TITLE 675 FIRE PREVENTION AND BUILDING SAFETY COMMISSION

Final Rule
LSA Document #19-330(F)

Rule 4.4. 2020 Indiana Residential Code

FIGURE R502.8
CUTTING, NOTCHING, AND DRILLING

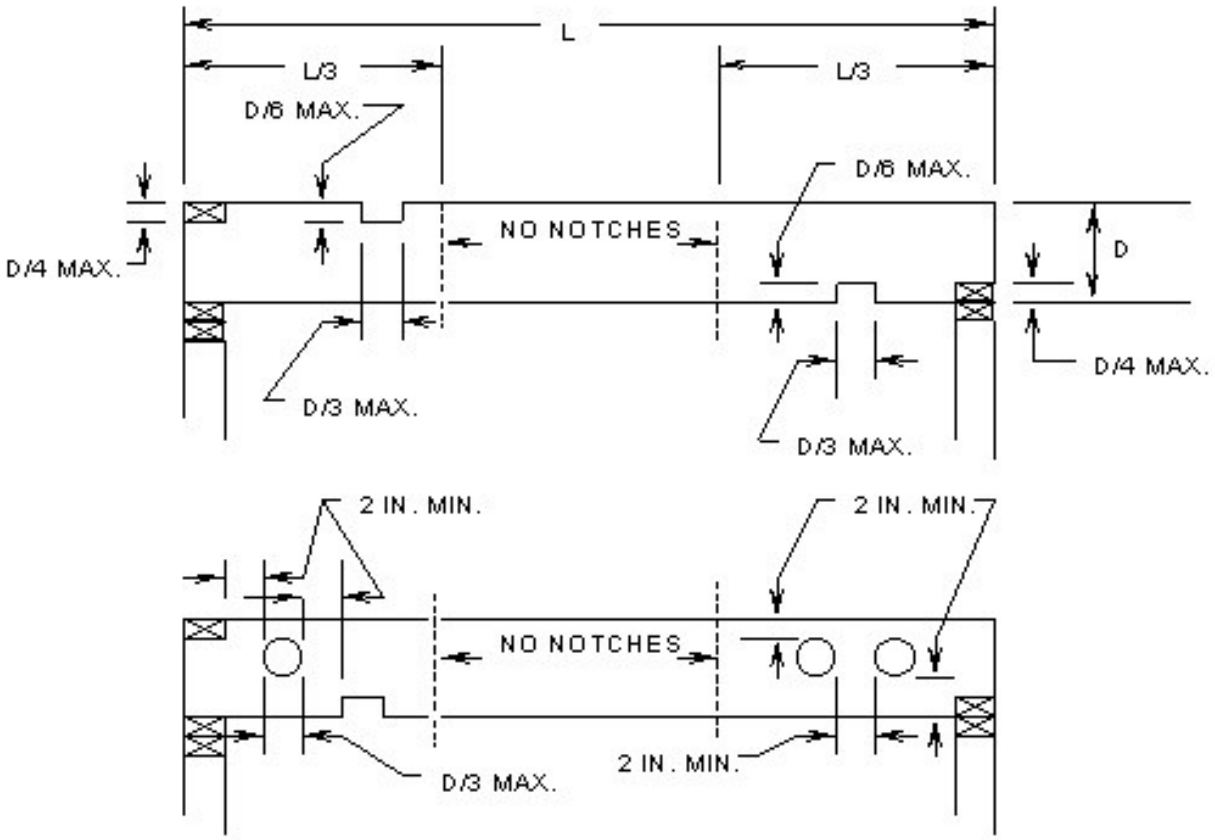
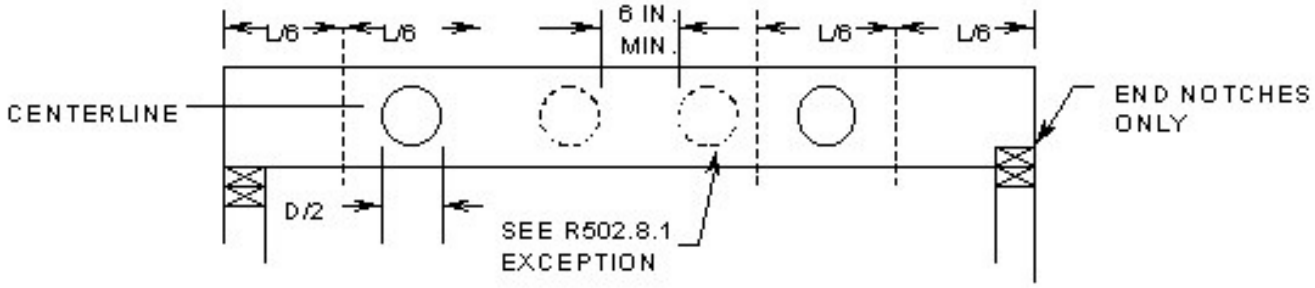
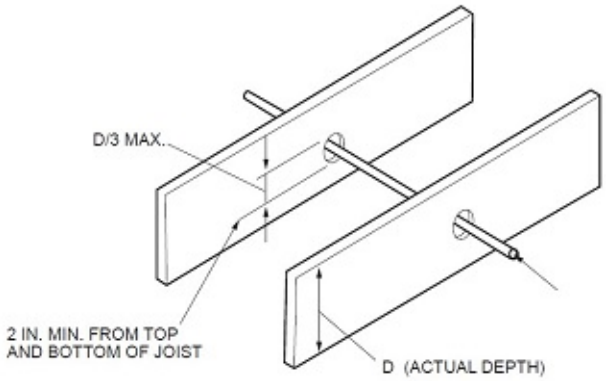
Sec. 59. Delete FIGURE R502.8 and substitute to read as follows: FIGURE R502.8:

Sec. 60. Add an EXCEPTION to the end of SECTION R502.8.1 to read as follows:
EXCEPTION: In 2 x 8 and larger solid lumber joists, holes up to 50 percent of the actual joist depth may be drilled at the center of the joist depth in the second and fifth sixths of the joist span. When the joist spans 90 percent or less of its maximum allowed span per Table R502.3.1(1) or R502.3.1(2), such holes may also be located in the center third of the joist span. Such hole shall be no closer than 6 inches (152 mm) from any other hole. Except for end notches, no notches may be in the same half of the span as a hole allowed by this exception.

FIGURE R703.7.6(1)

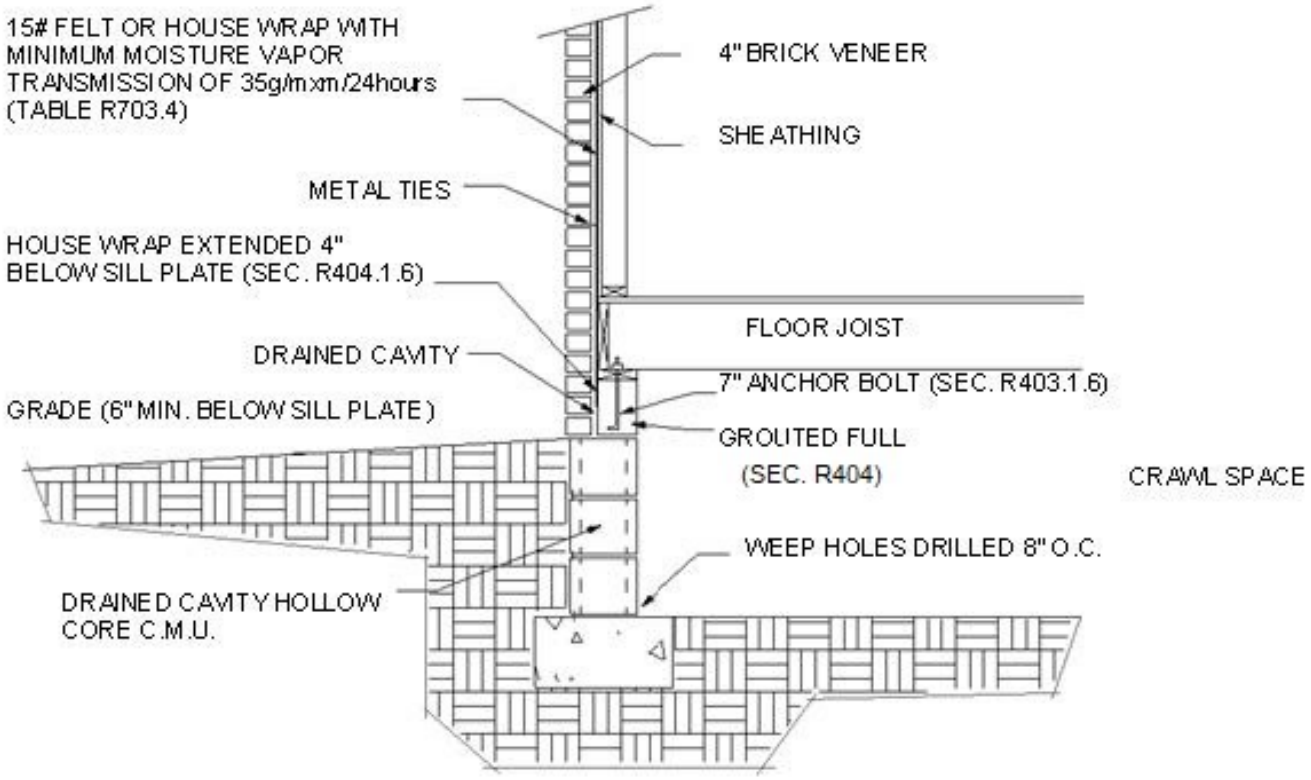
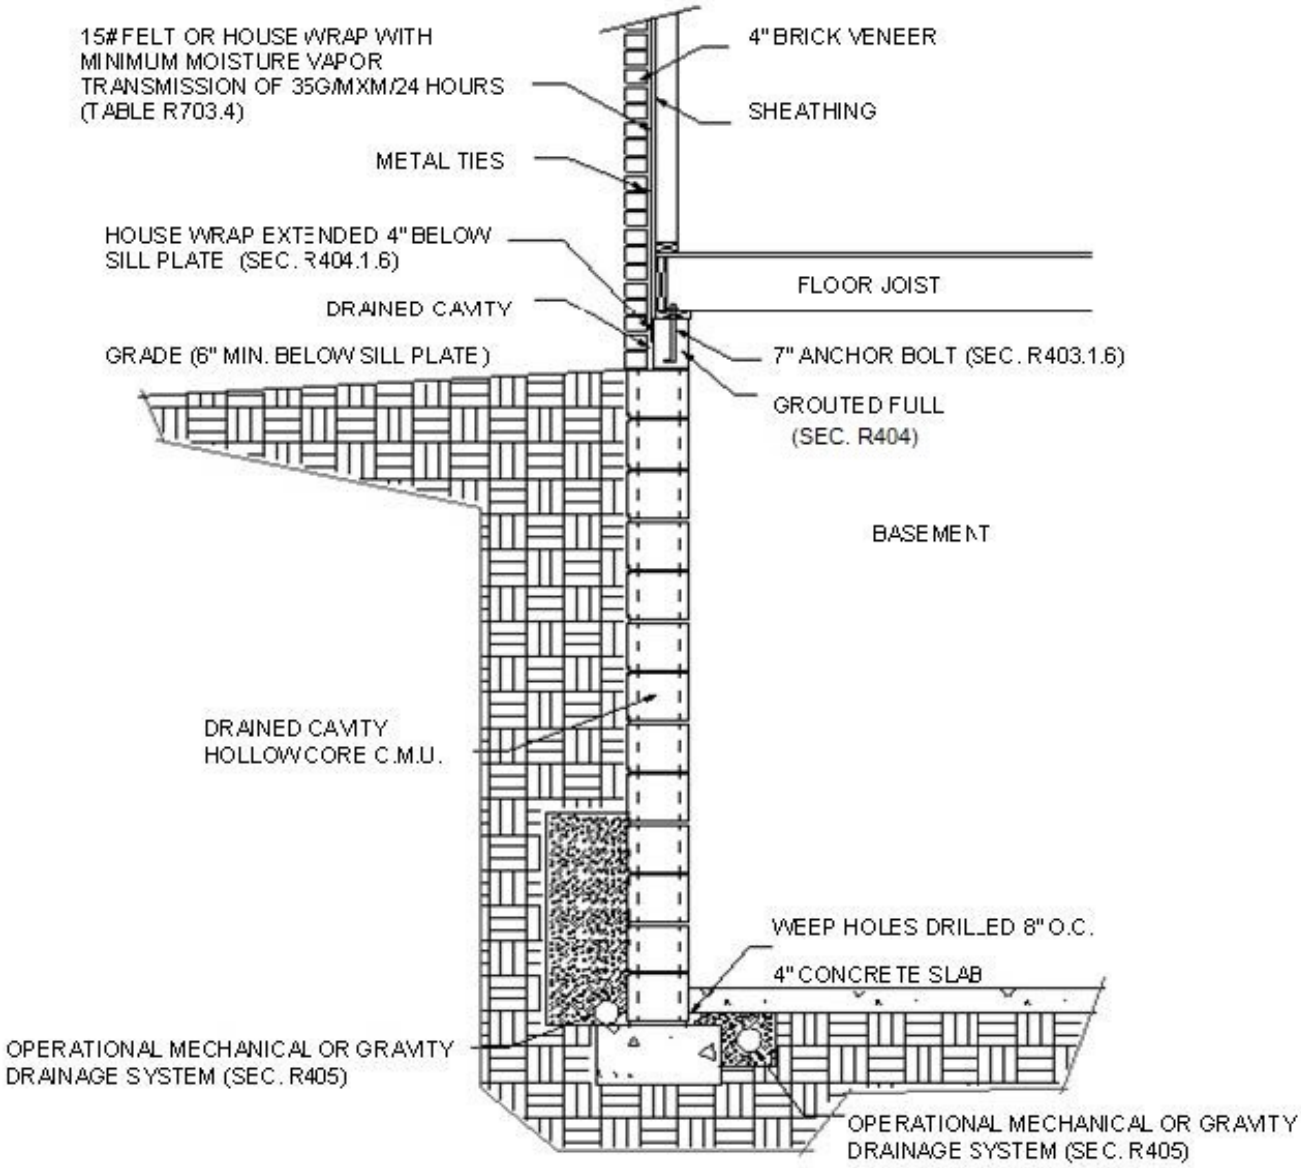
Sec. 79. Delete SECTION R703.8.6 in its entirety and substitute to read as follows:
SECTION R703.8.6 DRAINED CAVITY.
The 3/4 inch (19 mm) air cavity shall be drained to the exterior of the structure at intervals of not more than 33 inches (838 mm) on center. Each drain shall be not less than 3/16 inch (4.8 mm) in diameter, located immediately above the flashing. For dwellings with crawlspaces, the air cavity may be drained as shown in FIGURE R703.8.6(1). For dwellings with basements, the air cavity may be drained as shown in FIGURE R703.8.6(2).

FIGURE R1003.9 TERMINATION

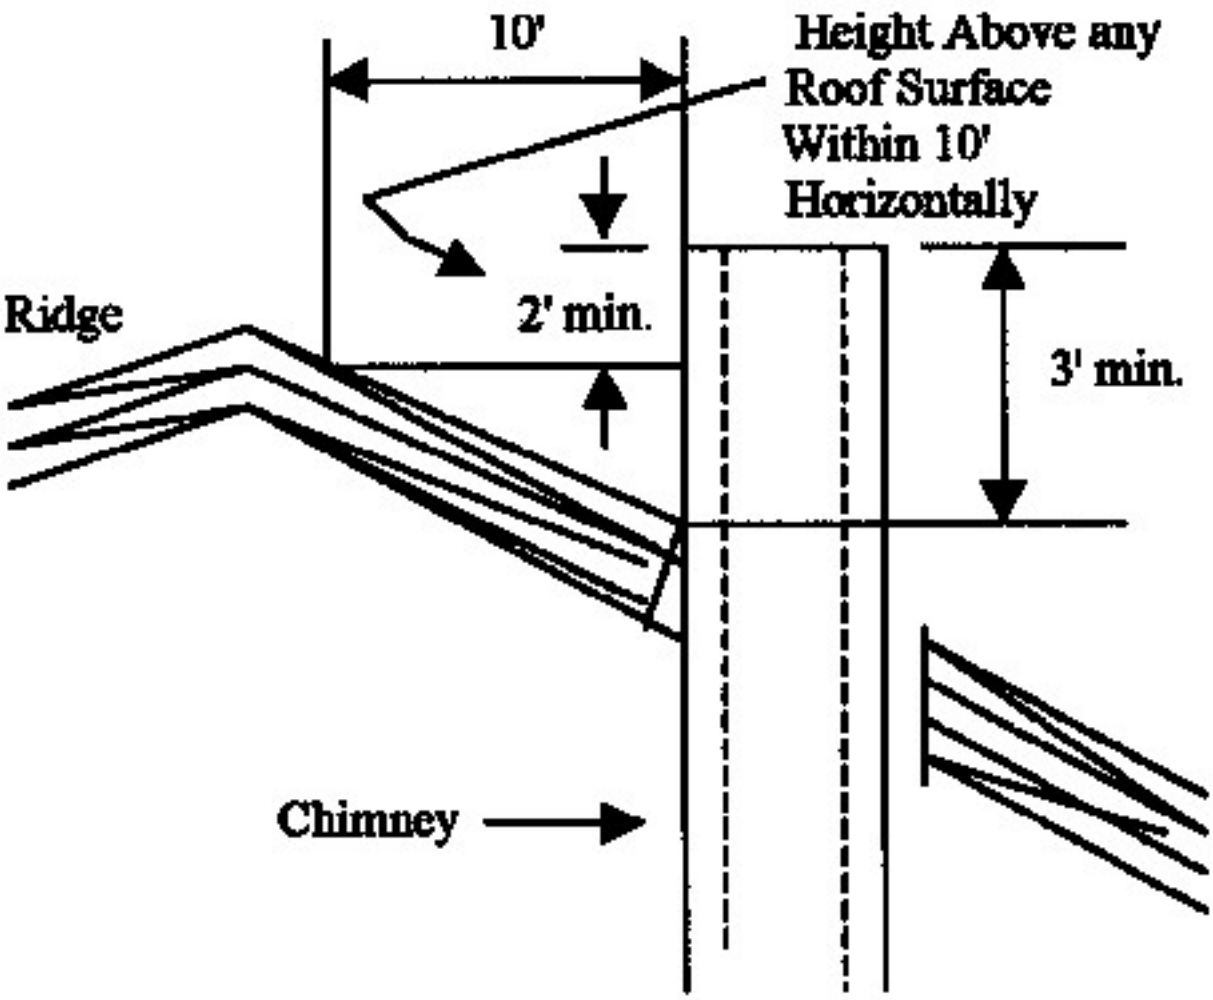
Sec. 88. Add FIGURE R1003.9 after SECTION R1003.9 as follows:
